Microcontroller Technical Information

Document No.	ZMT	F35-10-0011	1/3		
Integrated Development Environment Package	Date issued	Marc				
CubeSuite	Issued by	MCU Tool Product Marketing Department				
Usage Restrictions		MCL	Software Division			
		MCU Business Unit				
Related documents		Renesas Electronics Corporation				
None	Notification		Usage restriction			
	classification		Upgrade			
			Document modification			
			Other notification

CubeSuite (Product name: QS78K, QS850)

No. 1 Restrictions for IIC0 serial interface

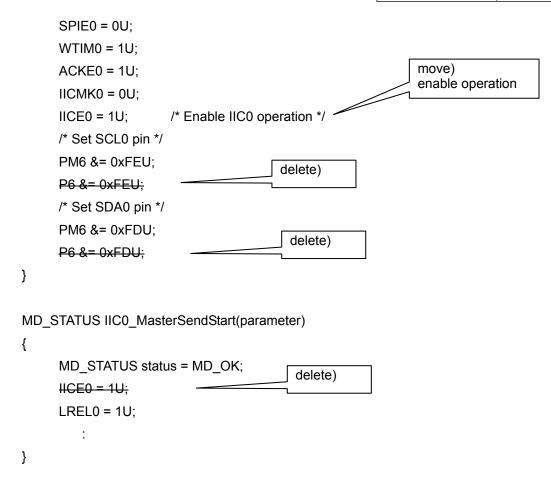
The procedure for initializing the IIC0 serial interface is different from the procedure described in the user's manual of the device.

The following functions in the output code pertain to the IIC0 serial interface.

Correct the sequence for setting the output latch to 0 and enabling operation described in pages 60 and 61 as follows.

```
void IIC0_Init(void)
{
            :
     /* Set INTIIC0 low priority */
     IICPR10 = 1U;
     IICPR00 = 1U;
     /* Set SCL0 pin */
                                  move)
     P6 &= 0xFEU;
                                  setting the output latch to 0
     /* Set SDA0 pin */
     P6 &= 0xFDU;
     IICCL0 = _00_IIC0_CLOCK0 | _00_IIC0_FILTER_OFF;
     IICX0 = _00_IIC0_EXPENSION0;
     SVA0 = _10_IIC0_MASTERADDRESS;
     STCEN = 1U;
     IICRSV = 1U;
```

This issue has been corrected in code generator Ver. 1.11 for the 78K0R/Kx3.

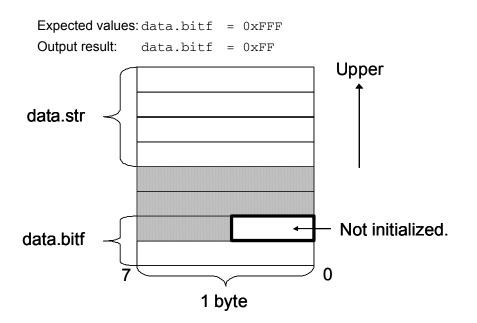
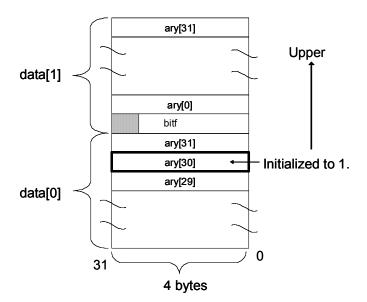
The higher 4 bits of data.bitf are not initialized.

The offset of the code used to set data[1].bitf to 1 ends up too low. data[0].ary[30] is initialized to 1. data[1].bitf ends up undefined.

```
Expected values: data[0].ary[30] = 0
data[1].bitf = 1
Output result: data[0].ary[30] = 1
```

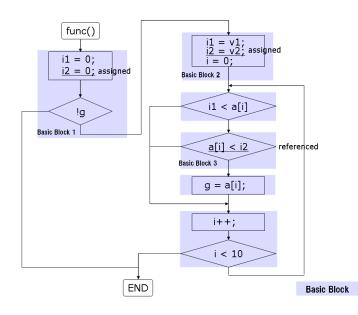
No.112 occurs when the following conditions are satisfied, resulting in moving the statement assigning variable X in Basic Block 1 to the back of the sentence assigning variable X in Basic Block 2 incorrectly:

- (1) Optimization level is -Og or higher (-Og, -O, -Os, -Ot, and associated code optimizations)
- (2) Control flow of function consists of Basic Blocks like (a) to (e).
 - (a) Either non-volatile automatic variable X or non-volatile argument variable X is assigned in both Basic Block 1 and 2, then referenced in Basic Block 3.
 - (b) The value assigned to variable X in Basic Block 2 is either volatile variable expression or peripheral I/O register expression.
 - (c) The path from Basic Block 1 is the only one merging into Basic Block 2.
 - (d) After Basic Block 2, both path-merging-into Basic Block 3 and path-not exist.
 - (e) No indirect access to variable X between Basic Block 1 and 3.
 - Note: A basic block is code that has one entry point, one exit point, and no jump instructions contained within it.
